W3F1-2004-0118

Subject: Correction to Annual Radiological Environmental Operating Report – 2003
Originally Submitted via Letter WF3-2004-0026
Waterford Steam Electric Station, Unit 3 (Waterford 3)
Docket No. 50-382
License No. NPF-38

Correction to Annual Radiological Environmental Operating Report - 2003

FIGURE 1-1

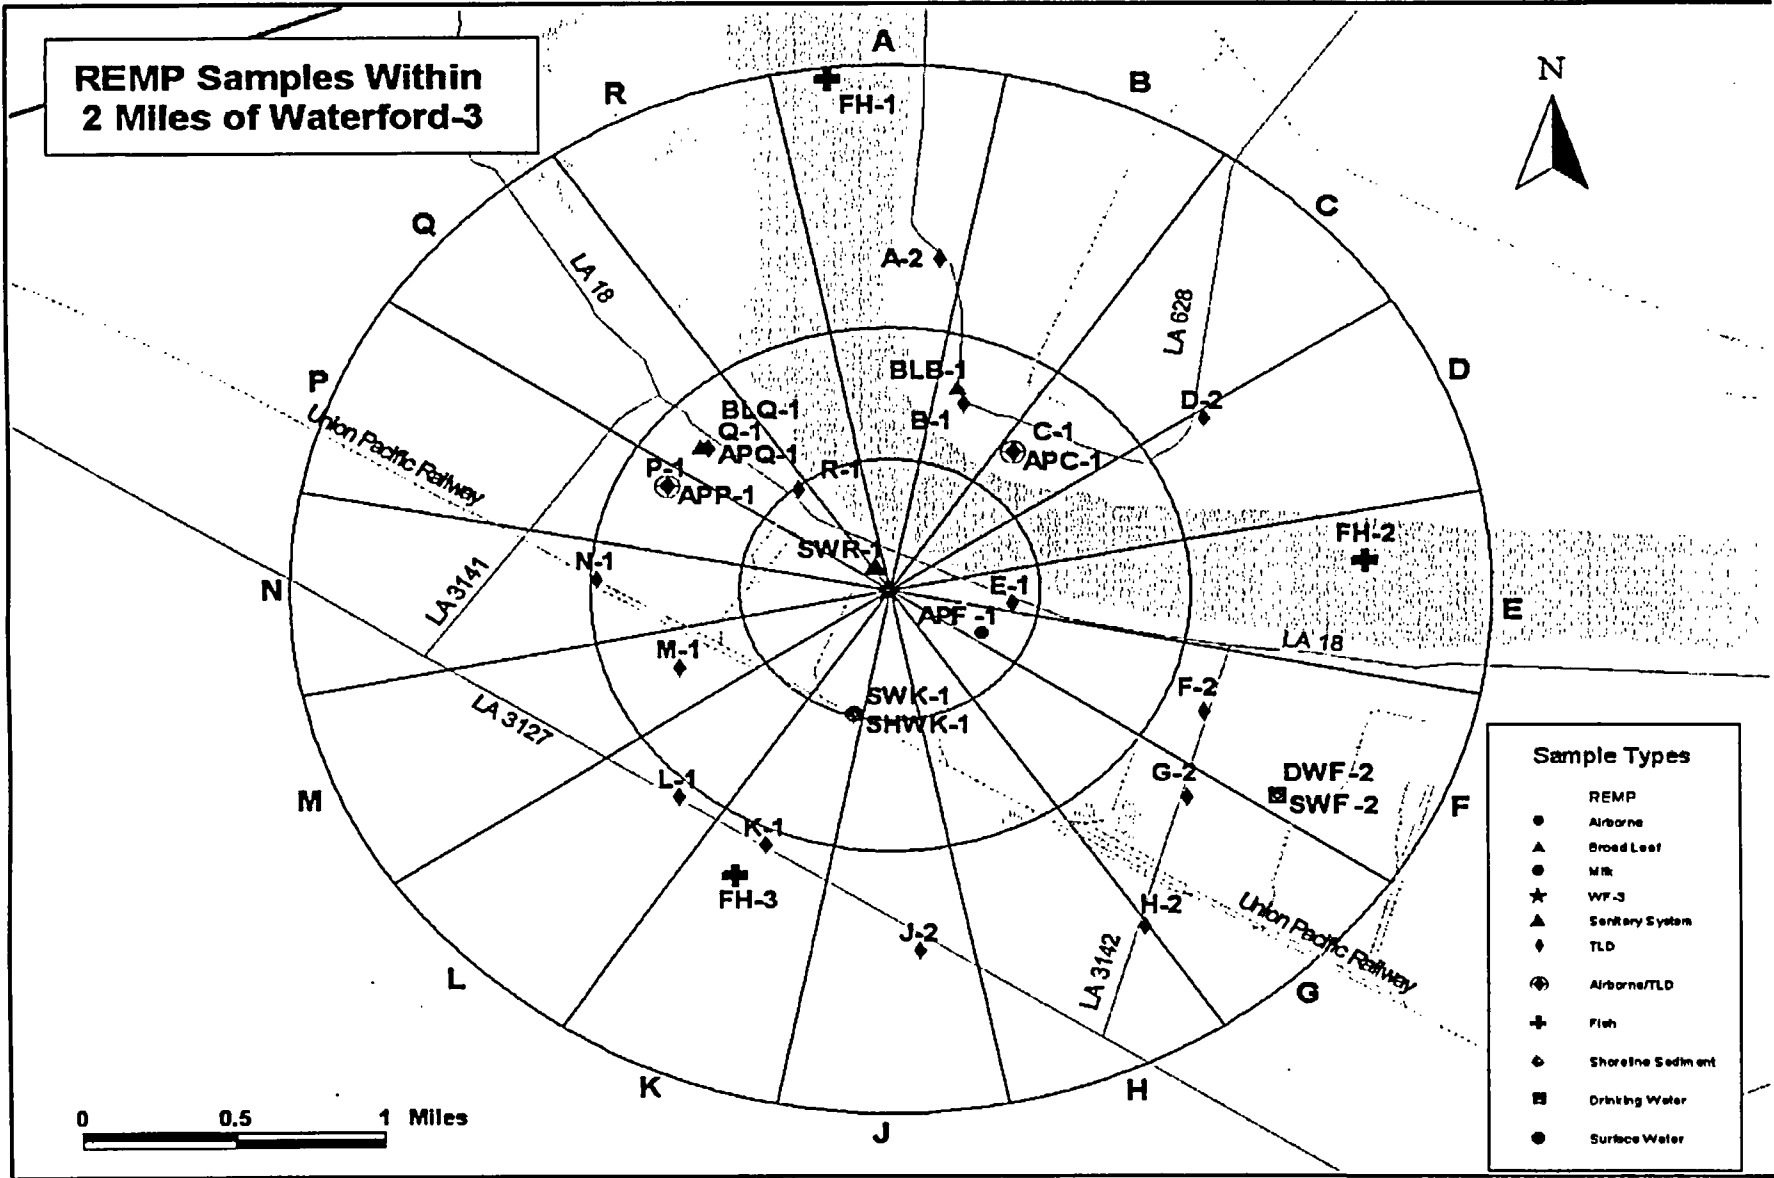
1. Figure 1-1, page 17: Changed APG-1 to APF-1
Changed DWG-2 to DWF-2
Changed SWG-2 to SWF-2

Although data points throughout the report are correct, the map in figure 1-1 was not updated to reflect the changes from sector G to F.
